**Meeting of the Central Valley Flood Protection Board
March 22, 2013**

Staff Report – Transmittal of Reclamation District 1001’s Letter of Intent for a System-Wide Improvement Framework to the U.S. Army Corps of Engineers

Reclamation District No. 1001
February 15, 2013

Response to RD 1001 2012 Draft Periodic Inspection Report

Encroachments

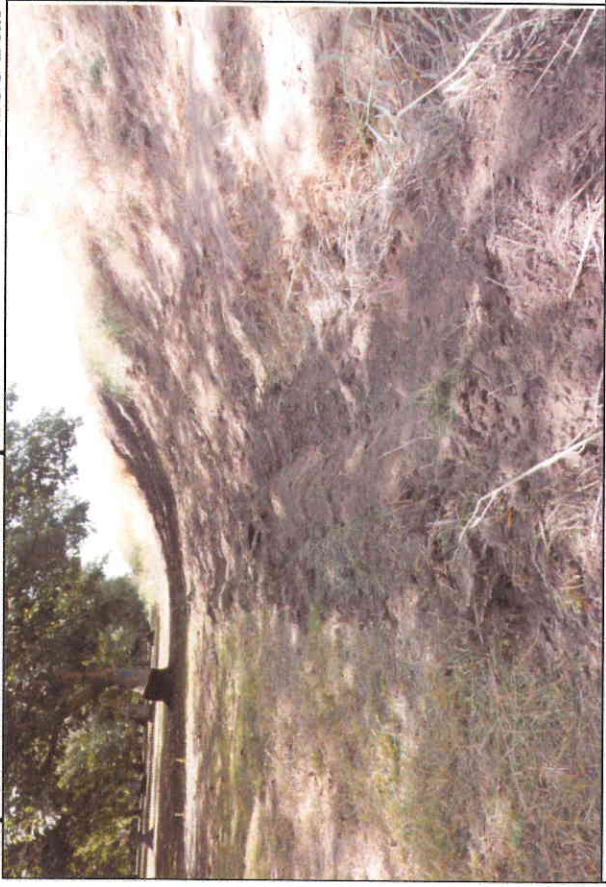
Inspect ID: NICU_2012_p_0188 **Title:** USACE_CESPK_NICU_2012_p_0188_1.jpg
Rated Item: 3. Encroachments **Caption:** Waterside toe cut, 24 inches deep, 150 feet long. Likely due to maintenance vehicles. (U)

September 2012: Waterside toe cut removed
Levee Mile: 3.46

Encroachments

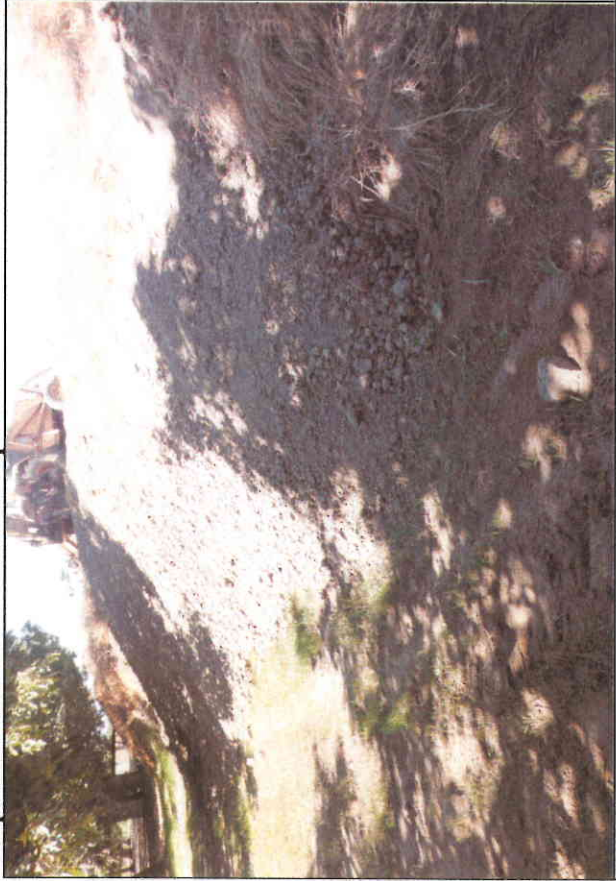
Inspect ID: NIC2_2012_p_0031 Title: USACE_CESPK_NIC2_2012_p_0031_1.jpg
Rated Item: 3. Encroachments Caption: Landside toe cut, up to 4 feet tall, 20 feet long.
(U)

September 2012: Landside toe cut removed. 10 cubic yards of dirt added to levee.
Levee Mile: .43

NIC2 South Yankee Slough Levee

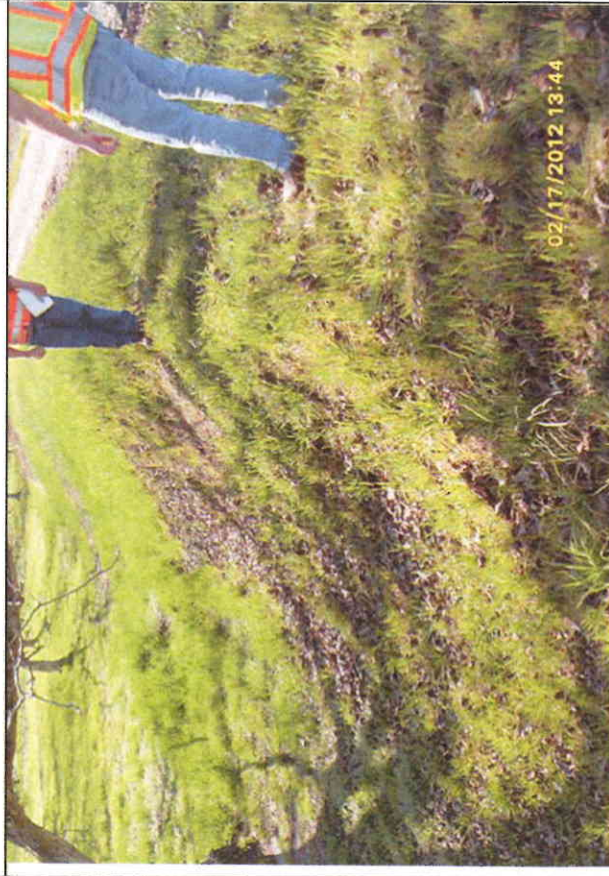
Inspect ID: NIC2_2012_p_0091 **Title:** USACE_CESPK_NIC2_2012_p_0091_1.jpg
Rated Item: 3. Encroachments **Caption:** Landside toe cut, about 5 feet tall, 30 feet long..
Landside slope is nearly vertical. (U)

September 2012: Landside toe cut removed. 8 cubic yards of dirt added to levee.
Levee Mile: 1.30

Encroachments

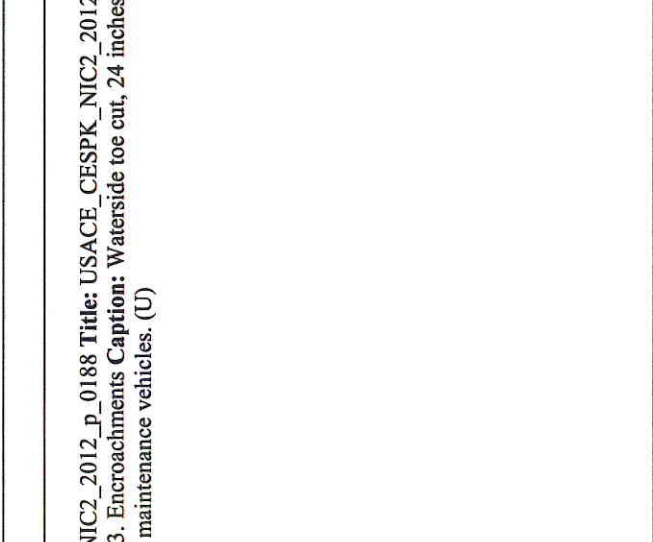
Inspect ID: NIC2_2012_p_0183 **Title:** USACE_CESPK_NIC2_2012_p_0183_1.jpg
Rated Item: 3. Encroachments **Caption:** Waterside toe cut, 24 inches tall, 100 feet long.-
Likely due to maintenance vehicles. (U)

September 2012: Waterside toe cut removed
Levee Mile: 2.94

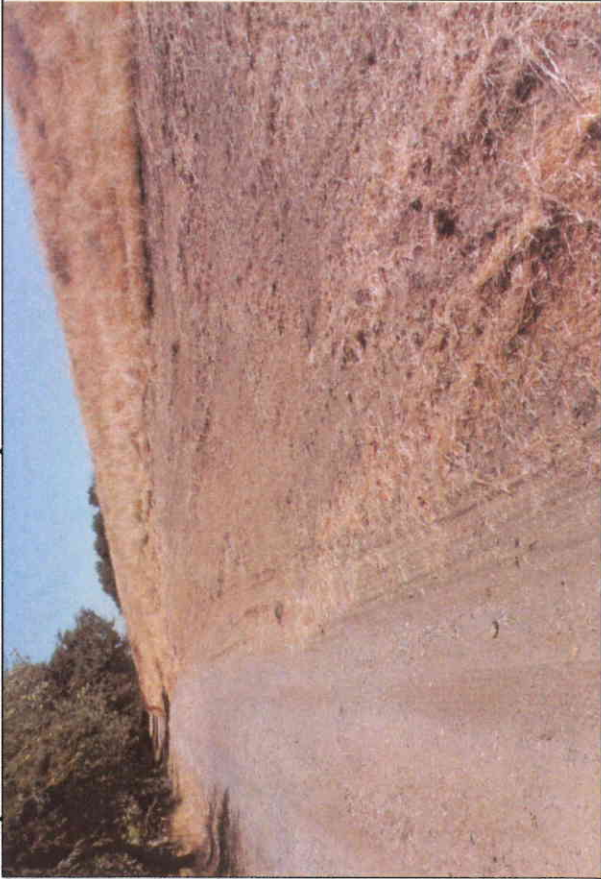
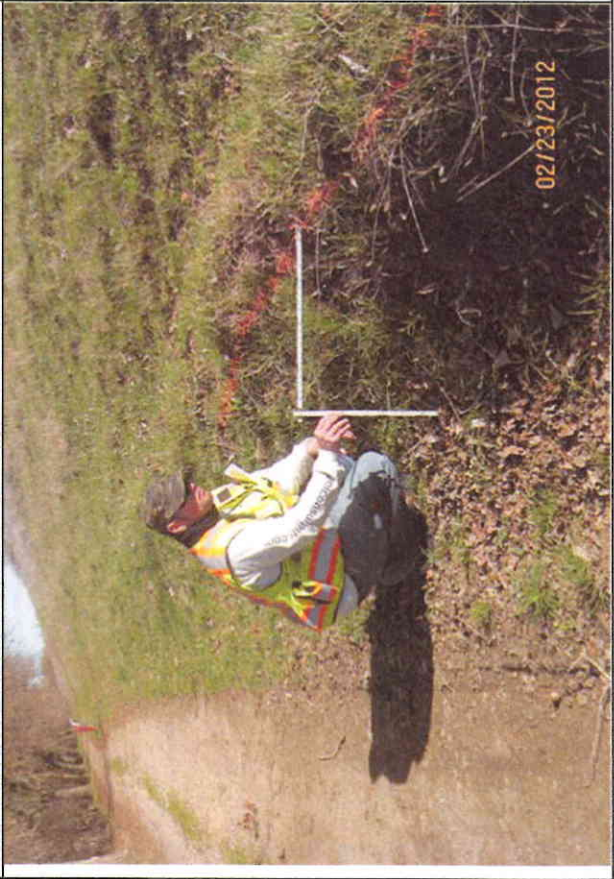
Inspect ID: NIC3_2012_p_0160 **Title:** USACE_CESPK_NIC3_2012_p_0160_1.jpg
Rated Item: 3. Encroachments **Caption:** Waterside toe cut, up to 3 feet tall, 350 feet long. Likely due to maintenance vehicles. (U)

August 2012: Waterside toe cut removed
Levee Mile: 12.41

Encroachments

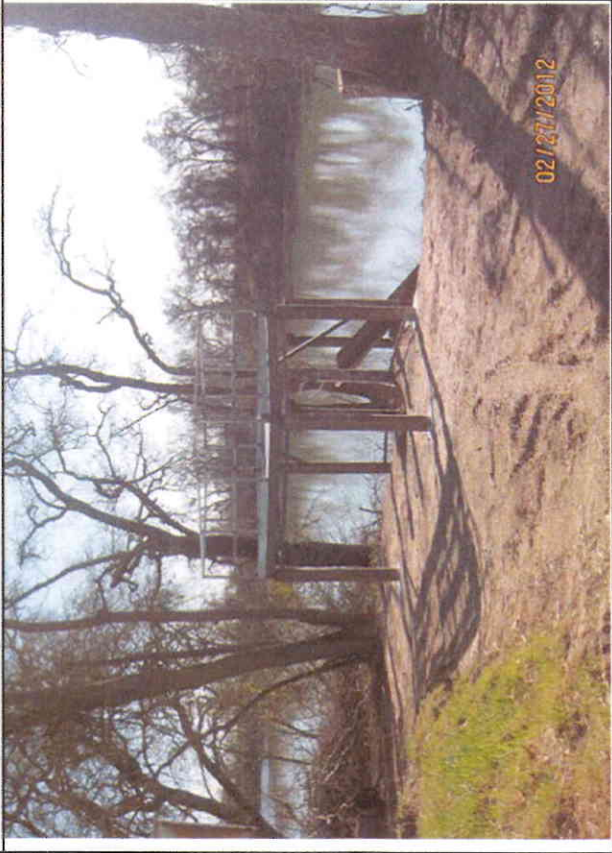
Inspect ID: NIC4_2012_p_0549 **Title:** USACE_CESPK_NIC4_2012_p_0549_3.jpg
Rated Item: 3. Encroachments **Caption:** 12 inch pipe through levee. Slant pump on waterside bank to 24 inch standpipe at landside toe. No positive closure on waterside shoulder. Pipe broken near siphon breaker on landside embankment. No inspection records available. (Permit No. 3297) (U)

September 28, 2012: Currently negotiating with property owner for removal and repair of pipe.
Levee Mile: 10.02

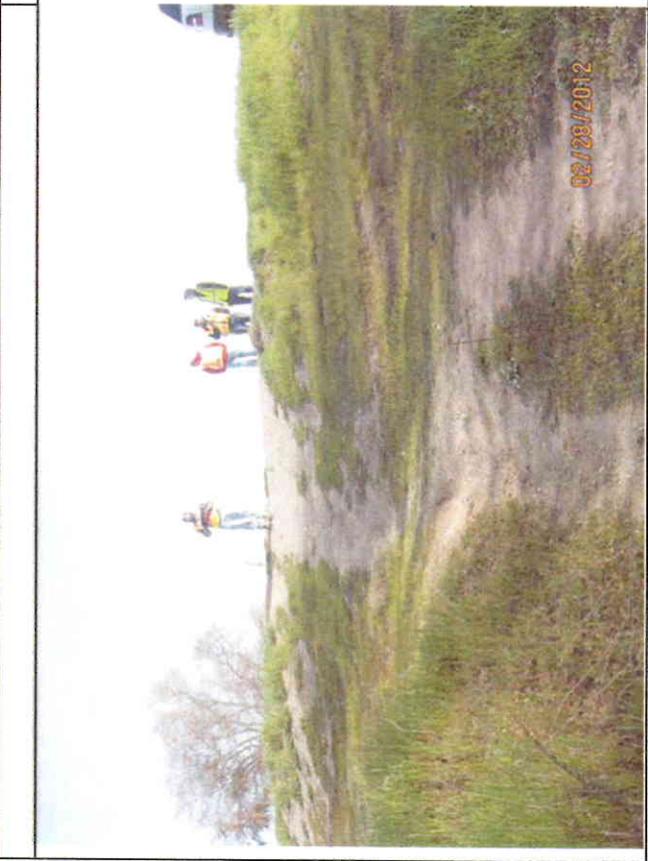
Inspect ID: NIC4_2012_p_0614 Title: USACE_CESPK_NIC4_2012_p_0614_1.jpg
Rated Item: 3. Encroachments Caption: Vertical landside toe cut up to 24 inches tall for a 100 foot stretch. (U)

September 2012: Landside toe cut removed
Levee Mile: 11.20

Encroachments

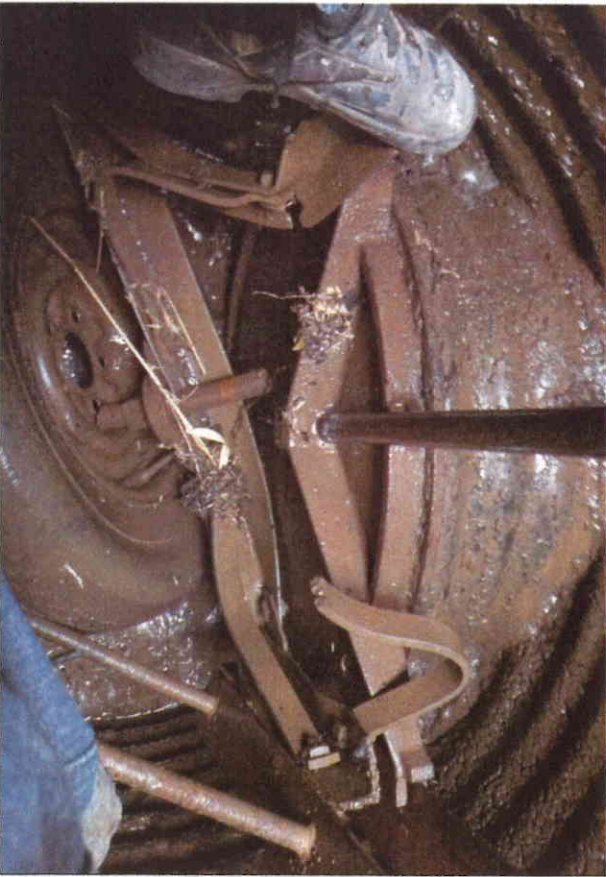
Inspect ID: NIC6_2012_p_0087 Title: USACE_CESPK_NIC6_2012_p_0087_1.jpg
Rated Item: 3. Encroachments Caption: 16 inch pipe through the levee. No positive closure device observed. Air break on landside hinge. Landside outlet is on the other side of the road. (Permit 13153) (U)

May 2012: Currently pump is permitted and active. Pump, pipes and adjacent structures are maintained by the property owner.
Levee Mile: 3.44
